**Editor's letter:**

I am sorry to say, there is still one major issue which must be modified or clearly mentioned as a strong limitation in the approach, as the problem modeled is different, and this must be said. In short, the 2D approximation for a 3D helicoidal cable is simply wrong, or not justified enough. The issue is in the appendix A, where all the modeling development is performed. At line 507, you mention that "because the plane wave incident upon layer 1 is assumed to lie in the X-Z plane", then "the problem becomes 2D". This is simply wrong. I try to show it in the figure below.

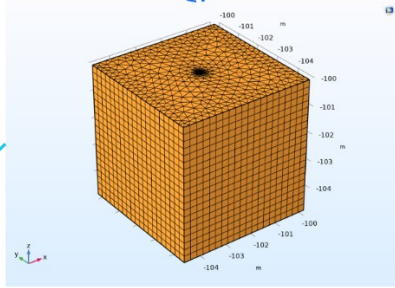
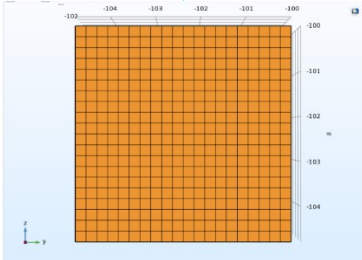
Line 255. I do not understand the issue with the graphics.

**Response:** The picture below should clarify that there are no meshing issues with COMSOL. Inside the domain, a tetrahedral mesh was employed, while lower reflecting surfaces were covered with a swept mesh.

• This Type of Mesh is mapped mesh. It is strongly recommended to use mapped meshing in the infinite boundaries to prevent poor mesh element quality, giving rise to poor or slow convergence for iterative solvers and making the problem ill-conditioned in general.

• This Type of Mesh is mapped mesh. It is strongly recommended to use mapped meshing in the infinite boundaries to prevent poor mesh element quality, giving rise to poor or slow convergence for iterative solvers and making the problem ill-conditioned in general.
